DAVIS
PARTNERSHIP
ARCHITECTS

ADDENDUM NO: 03

Date Issued: December 9, 2015

**Re: Red Rocks Community College
Student Recreation Center**
Construction Documents, Dated November 9, 2015
Architect's Project No. 15803.00

① ENLARGED TELECOM MDF ROOM PLAN
1" = 1'-0"

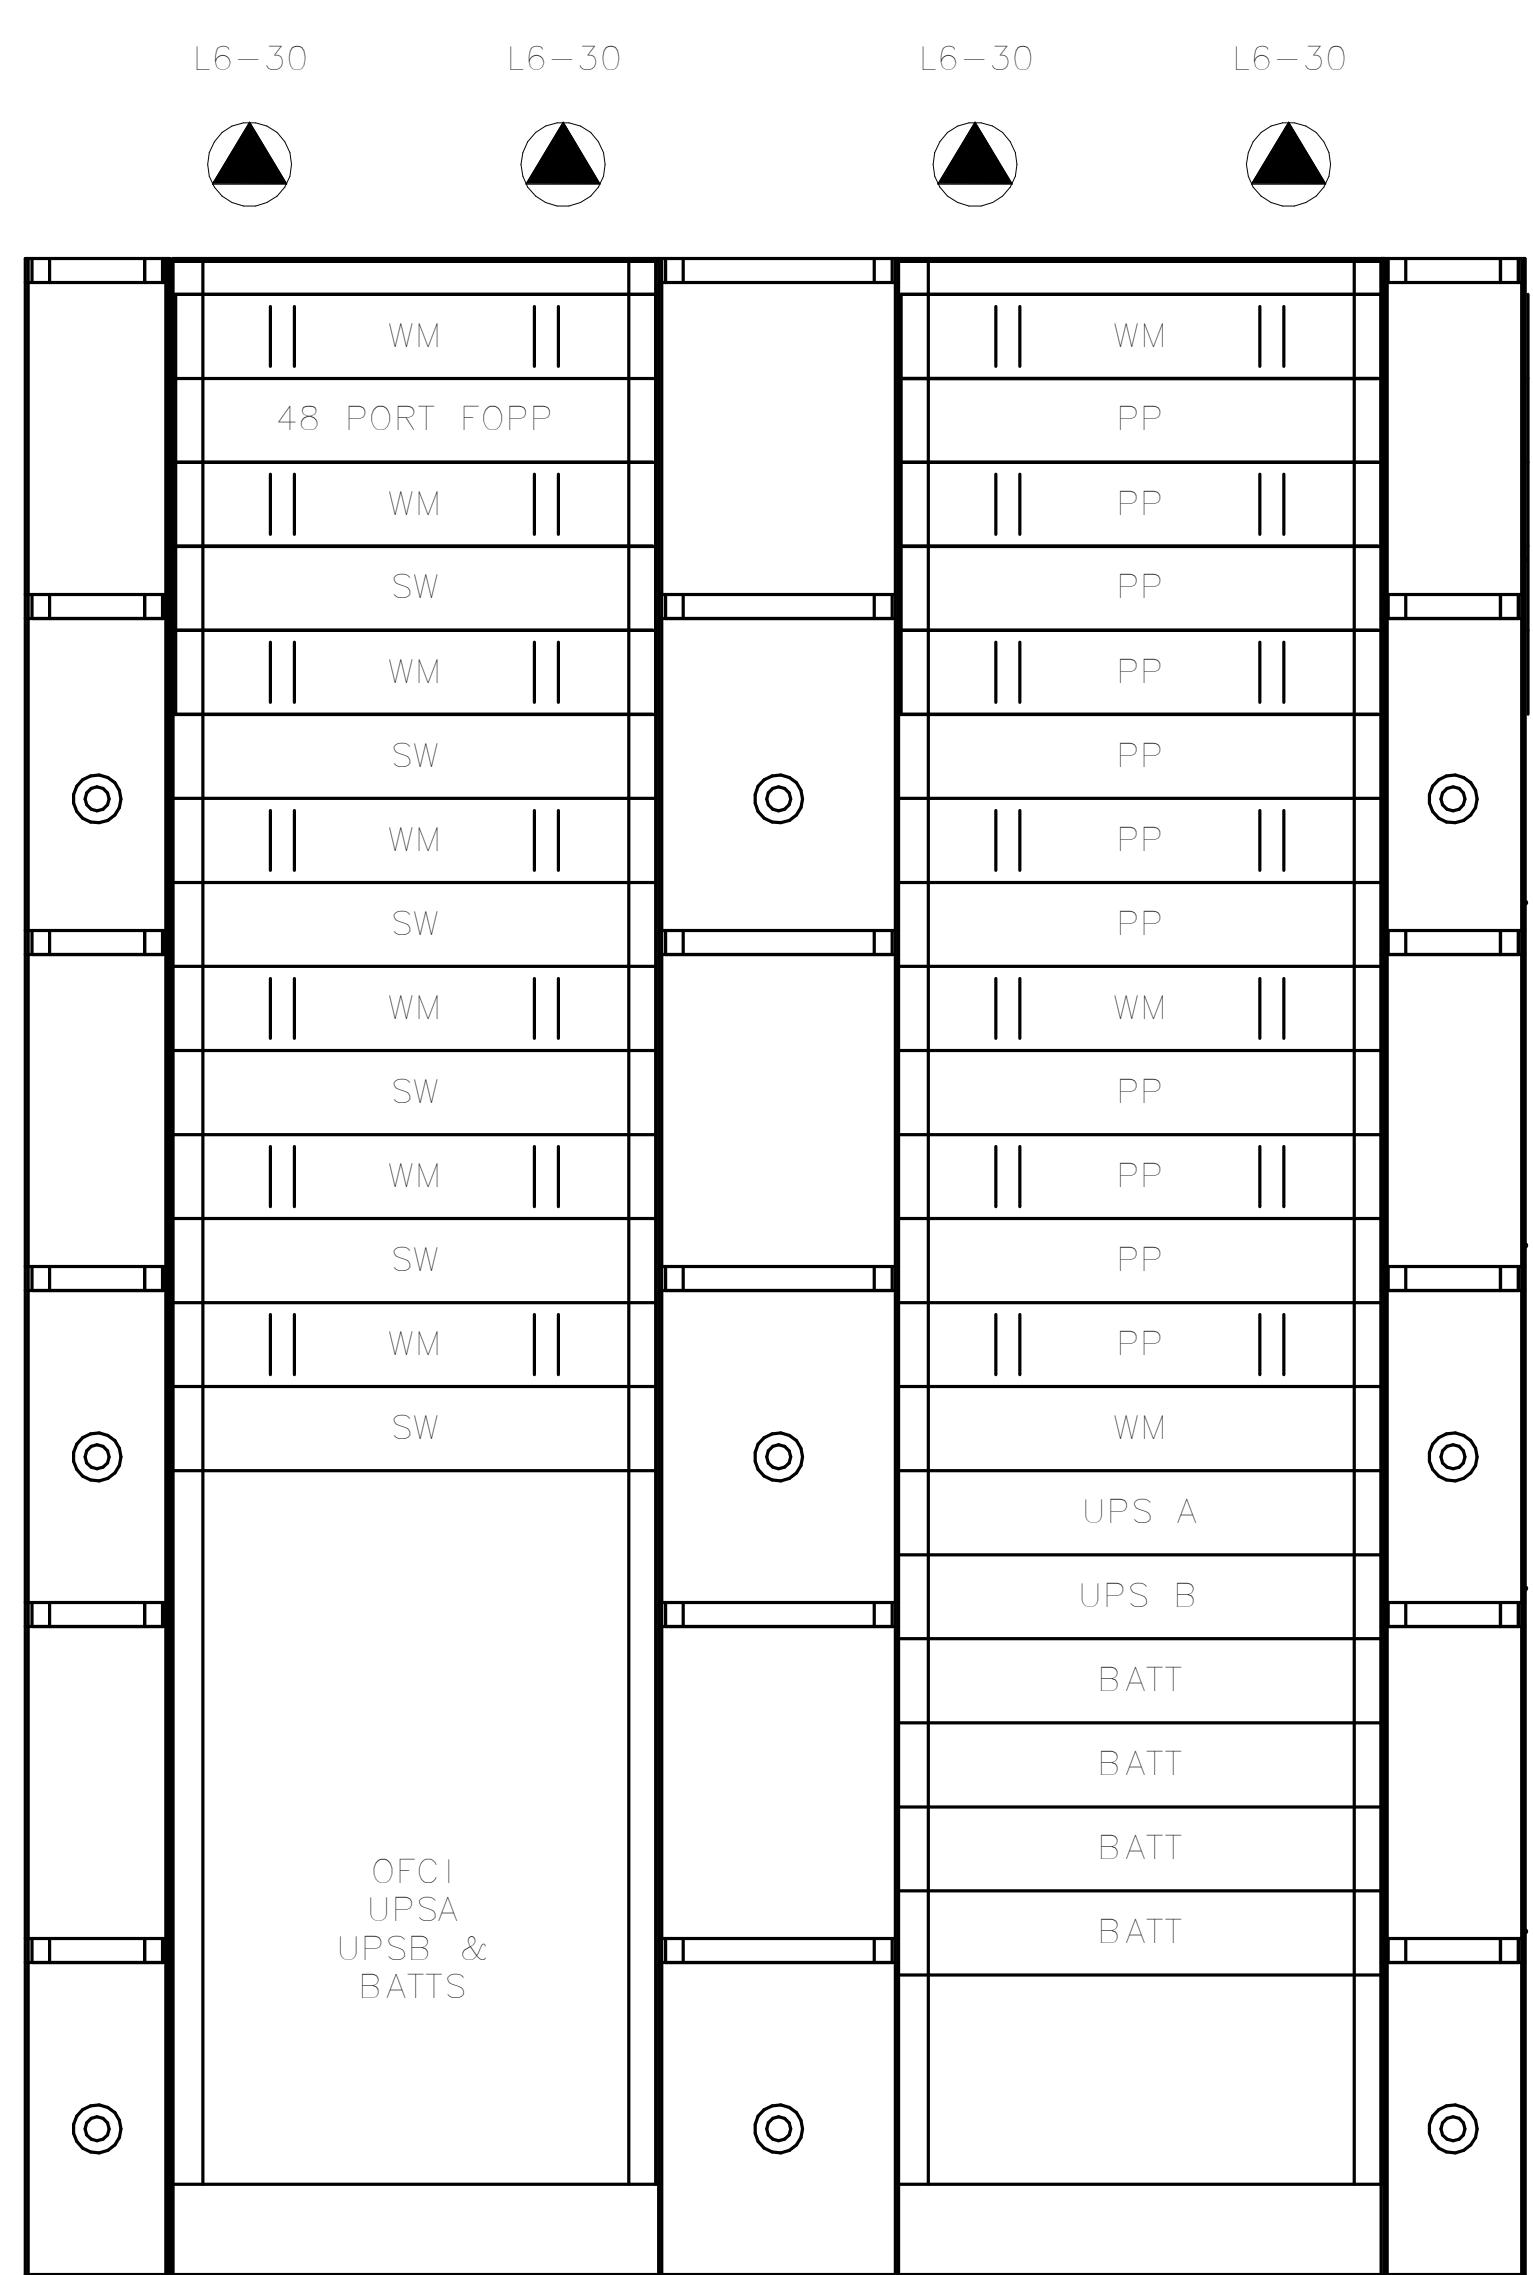
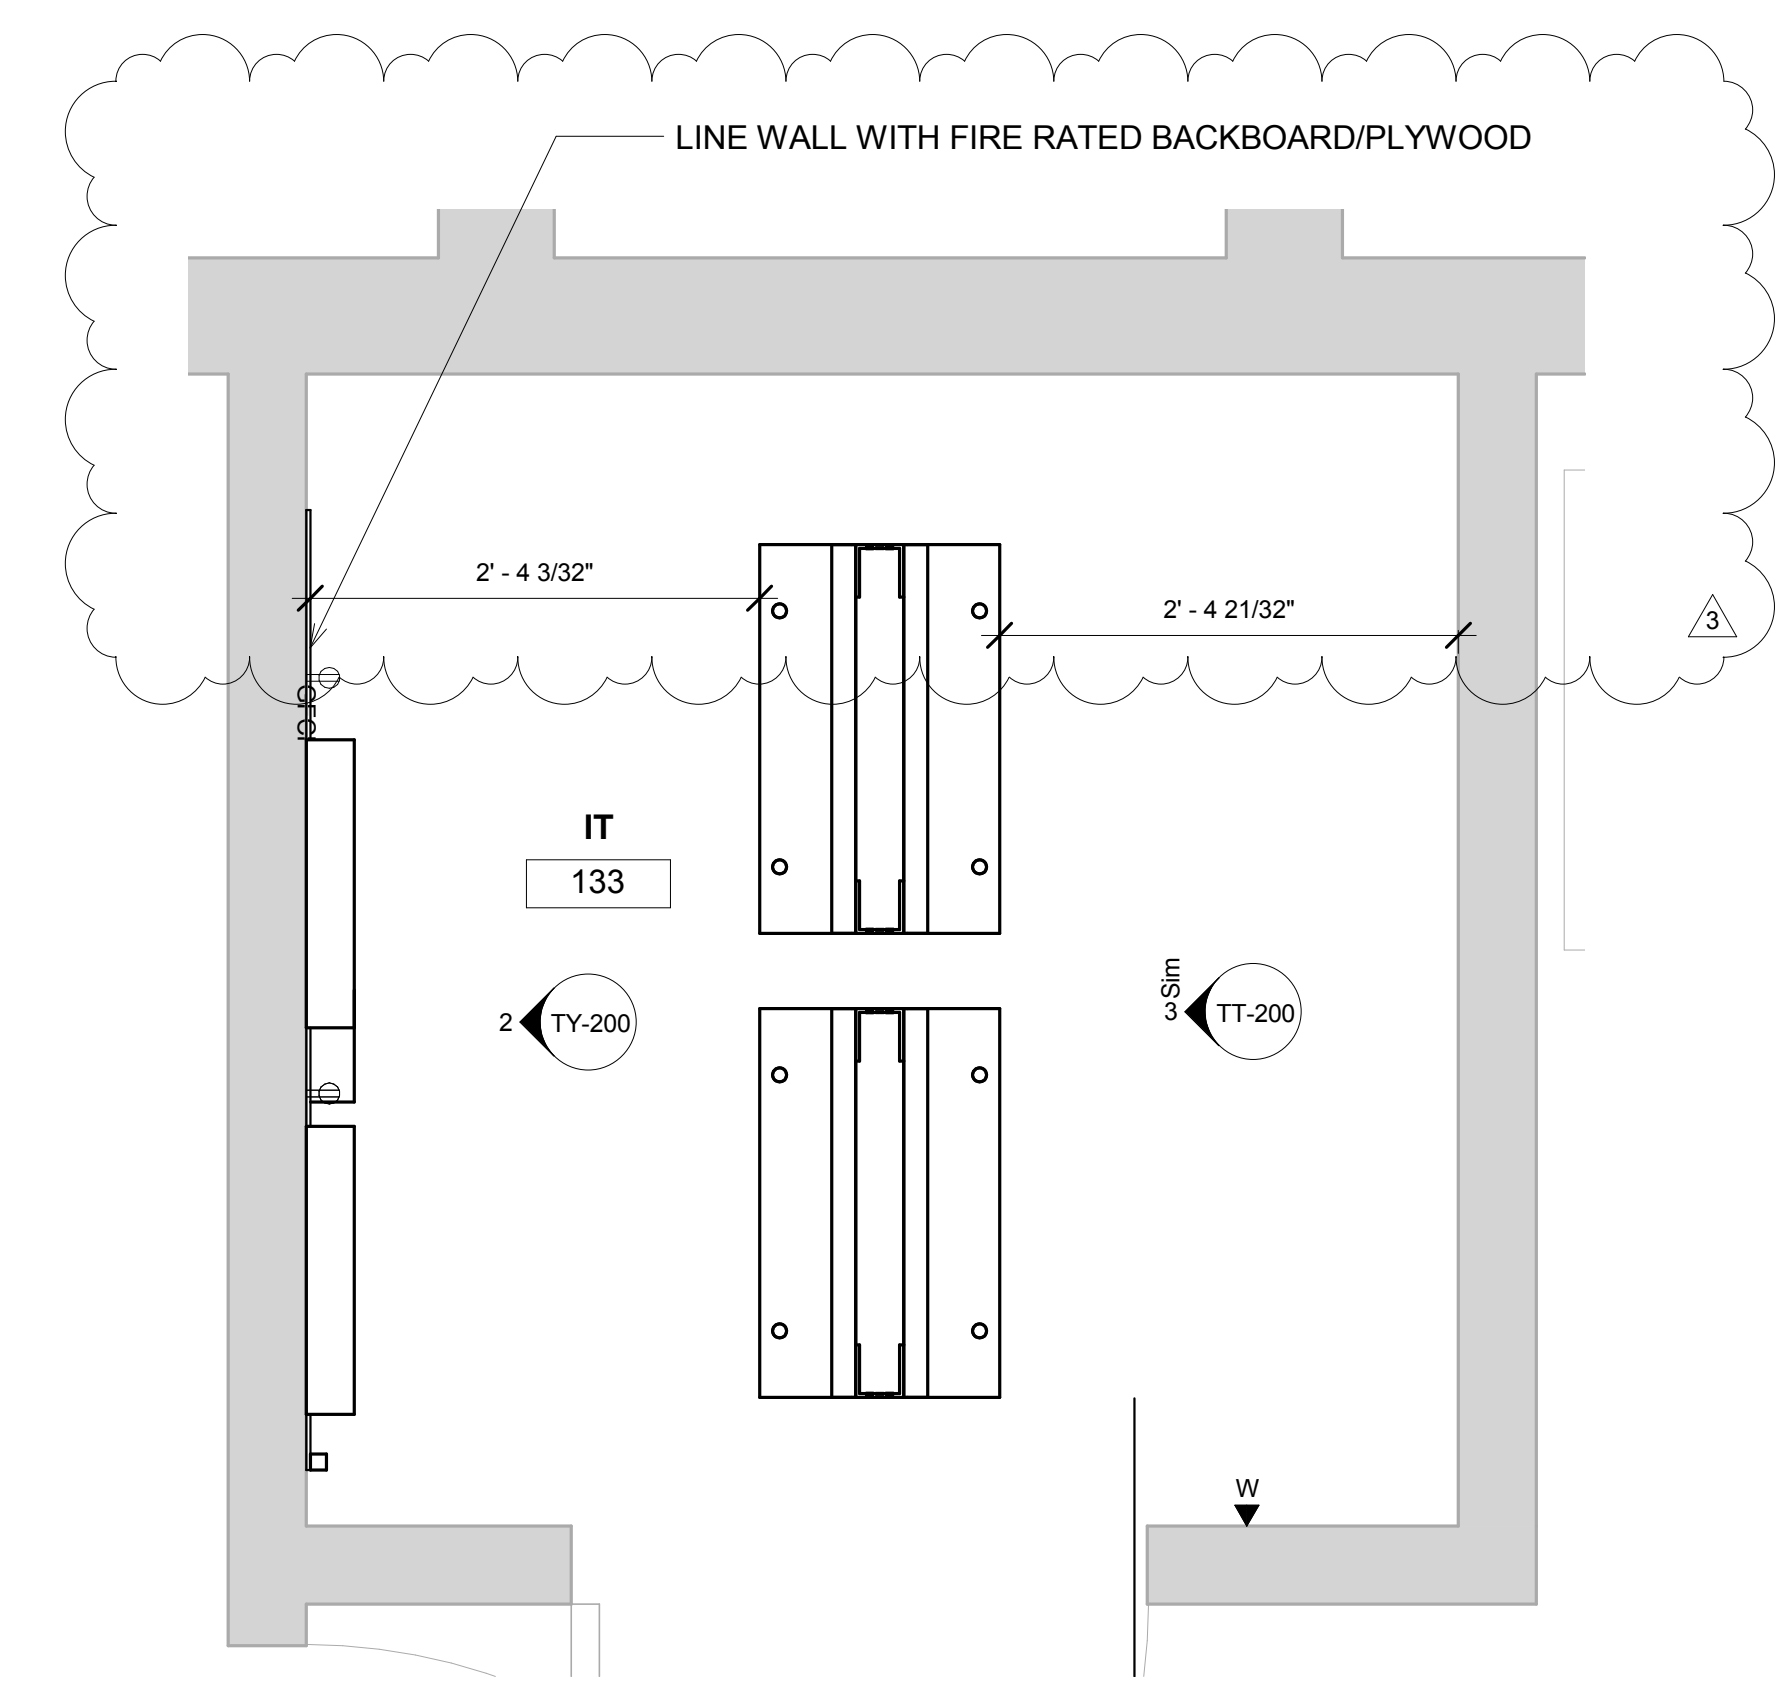
- ADD. #3-43. Regarding the MDF/IDF. Will these rooms require any backboard plywood? **SMW RESPONSE: Designated wall in Addendum 3 drawing TT-200 to be lined with fire rated plywood.**

- i How many walls will require backboard plywood? **SMW RESPONSE: One Designated wall in Addendum 3 drawing TT-200 to be lined with fire rated plywood.**

ADD. #3-90. TT-200 – Added fire rated plywood to designated wall and removed note referencing 600 pr
